# RA6M3 Group

Evaluation Kit for RA6M3 Microcontroller Group  
EK-RA6M3 v1  
Errata

EK-RA6M3 v1 – Errata

Figure 1. C28 and C29 Location

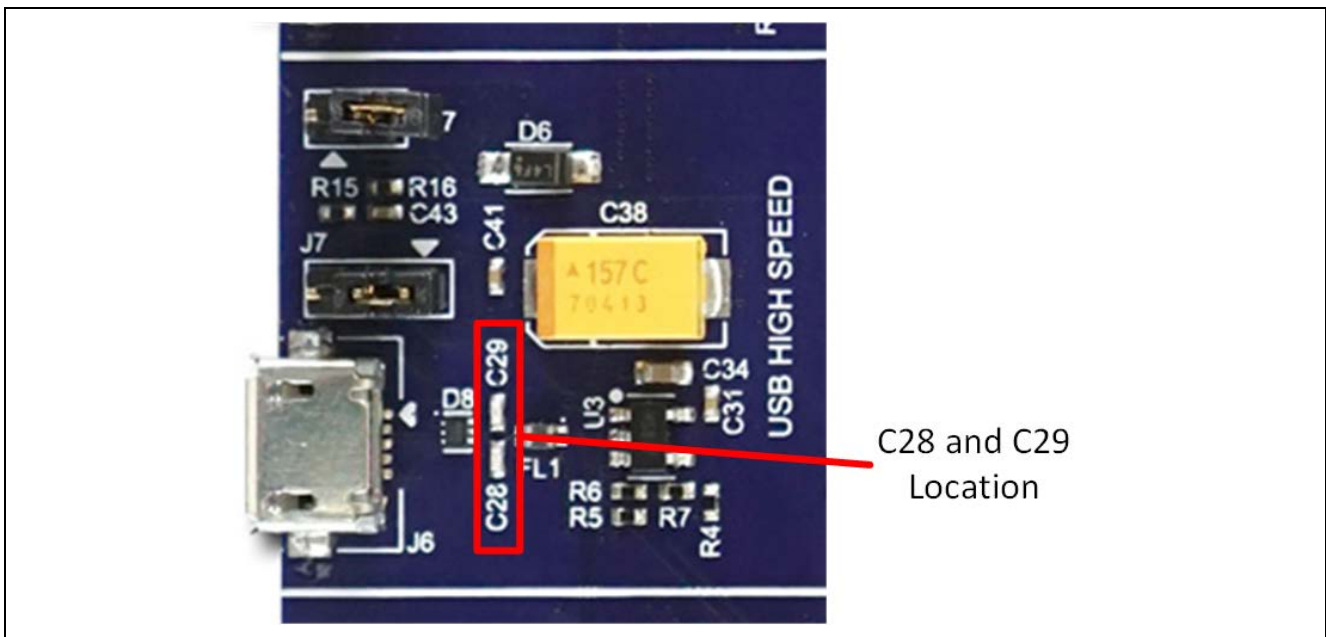
The USB High Speed (USB HS) port may exhibit connection problems or performance degradation when operating the USB HS port at the highest specified speed.

To improve the function of the USB HS port, remove capacitors C28 and C29.

Figure 2. Package Type on Silk Screen

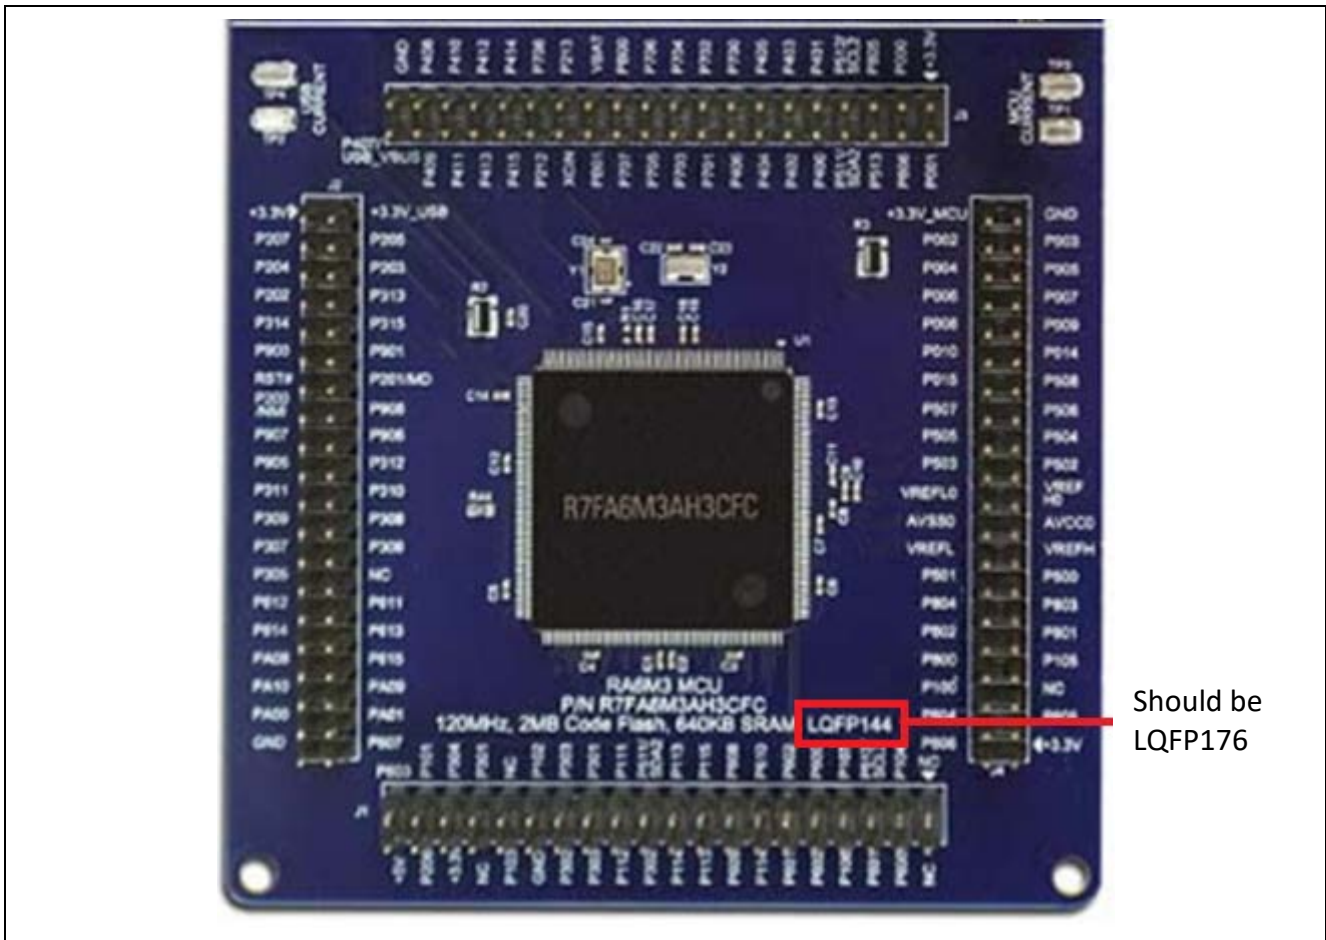
The silk screen on the EK-RA6M3 board shows an incorrect package type for the RA6M3 MCU. The incorrect silk screen identifies the package type as LQFP144. The actual package type is LQFP176.

No corrective action is needed. The silk screen is correct on later builds of the board.

Figure 3. P105 Rework Pin Locations

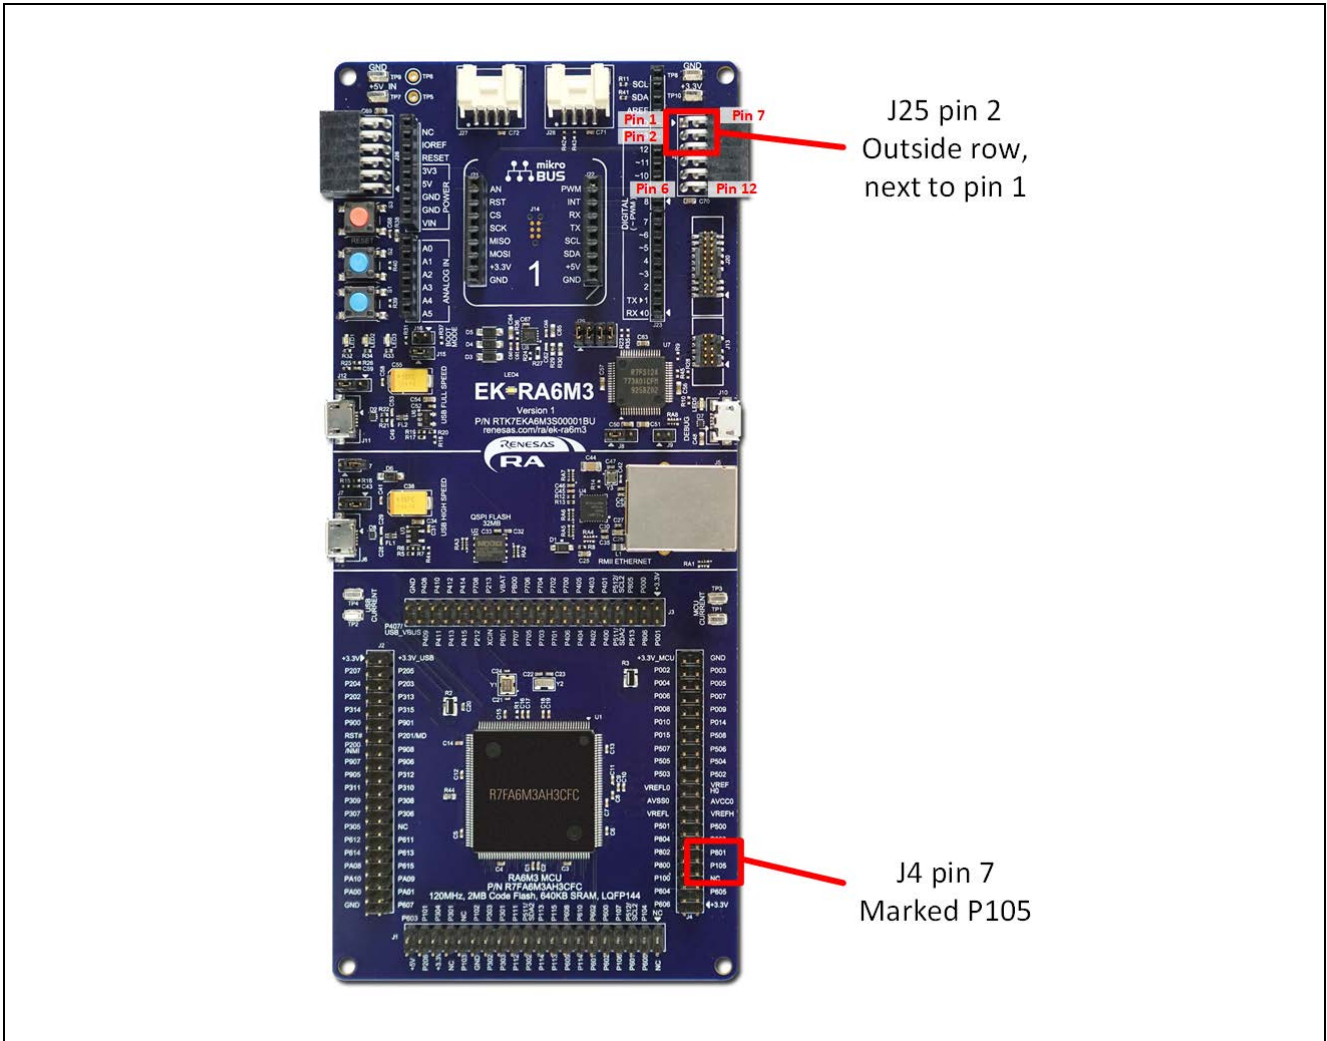
P105 is not connected between J4 pin 7 and J25 pin 2. As a result, PMOD 2 may not function correctly.

A wire may be added between J4 pin 7 and J25 pin 2. This will add the correct functionality to PMOD 2. It is recommended to add rework wire on the bottom side of the board.

This error has been corrected on later builds of the board.

Figure 4. USB Full Speed Rework Locations

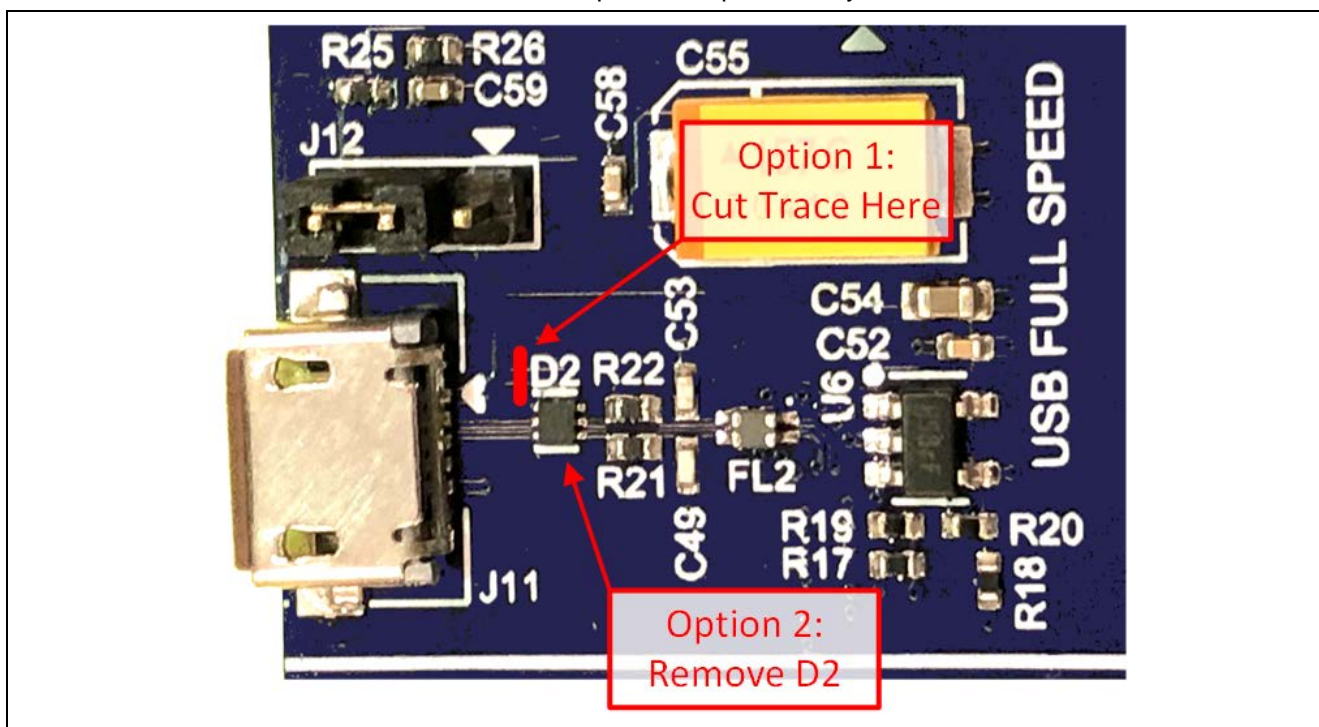
When configured in Device Mode, the USB Full Speed peripheral in the RA6M3 MCU uses the USB\_VBUS signal (P407) to detect the presence of a USB cable connected to J11. Due to voltage leakage through the ESD protection circuit D2, the voltage on P407/USB\_VBUS may not drop low enough to detect detaching a cable at J11. This may prevent the USB Full Speed port from detecting that cable has been disconnected. The issue occurs when a cable is first connected to the USB port and is properly configured, then the cable is disconnected.

There are two possible methods to enable correct operation of the USB Full Speed port in self-powered mode. Implementing either method will resolve the issue. It is not necessary to implement both methods.

1. (Recommended) Cut the +5V trace between D2 pin 6 and the rest of the USB Full Speed +5V trace. Cut the trace at the location indicated by the arrow in Figure 4. The trace is located next to the D2 reference designator on the top side of the circuit board.
2. Remove D2. This will eliminate the voltage leakage between the USB Full Speed data lines and the USB +5V. However, this will also remove the ESD protection provided by D2.

Figure 5. USB High Speed Rework Locations

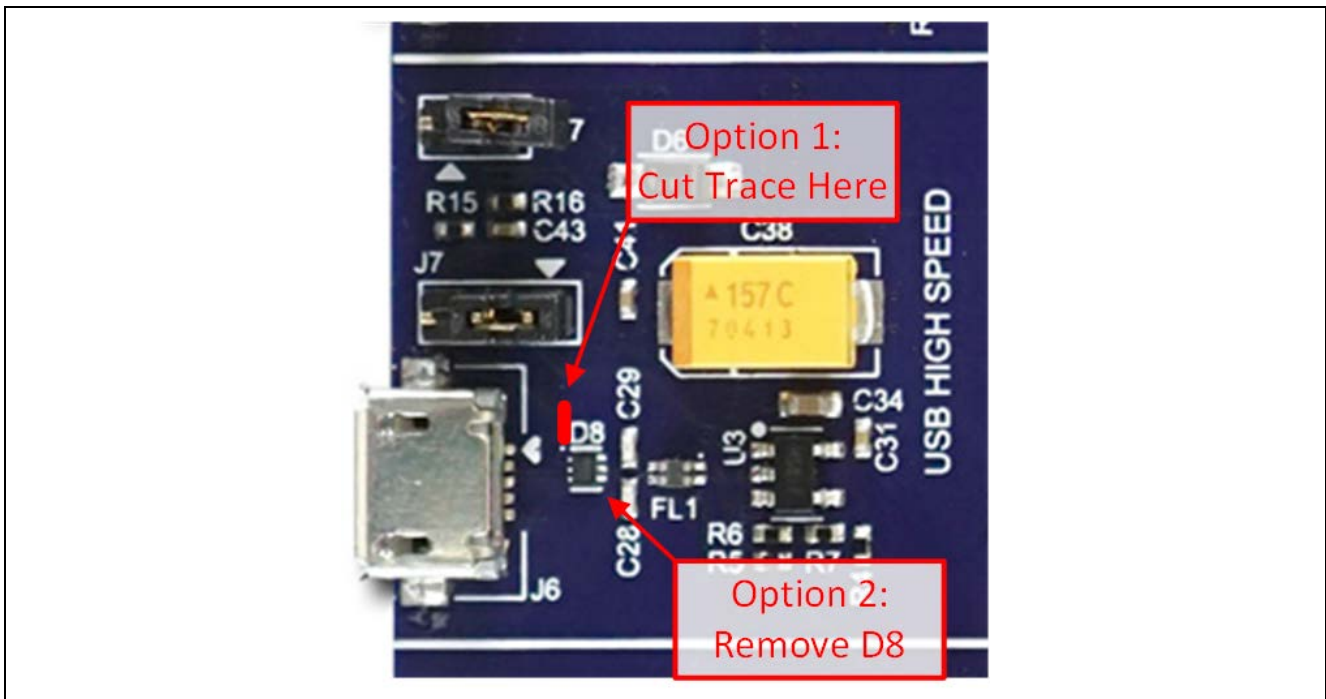
When configured in Device mode, the USB High Speed peripheral in the RA6M3 MCU uses the USBHS\_VBUS signal (PB01) to detect the presence of a USB cable connected to J6. Due to voltage leakage through the ESD protection circuit D2, the voltage on PB01/USBHS\_VBUS may not drop low enough to detect detaching a cable at J6. This may prevent the USB High Speed port from detecting that the cable has been disconnected. The issue occurs when a cable is first connected to the USB port and is properly configured, then the cable is disconnected.

There are two possible methods to enable correct operation of the USB Full Speed port in self-powered mode. Implementing either method will resolve the issue. It is not necessary to implement both methods.

1. (Recommended) Cut the +5V trace between D8 pin 6 and the rest of the USB High Speed +5V trace. Cut the trace at the location indicated in Figure 5. The trace is located next to the D8 reference designator on the top side of the circuit board.
2. Remove D8. This will eliminate the voltage leakage between the USB High Speed data lines and the USB +5V. However, this will also remove the ESD protection provided by D8.
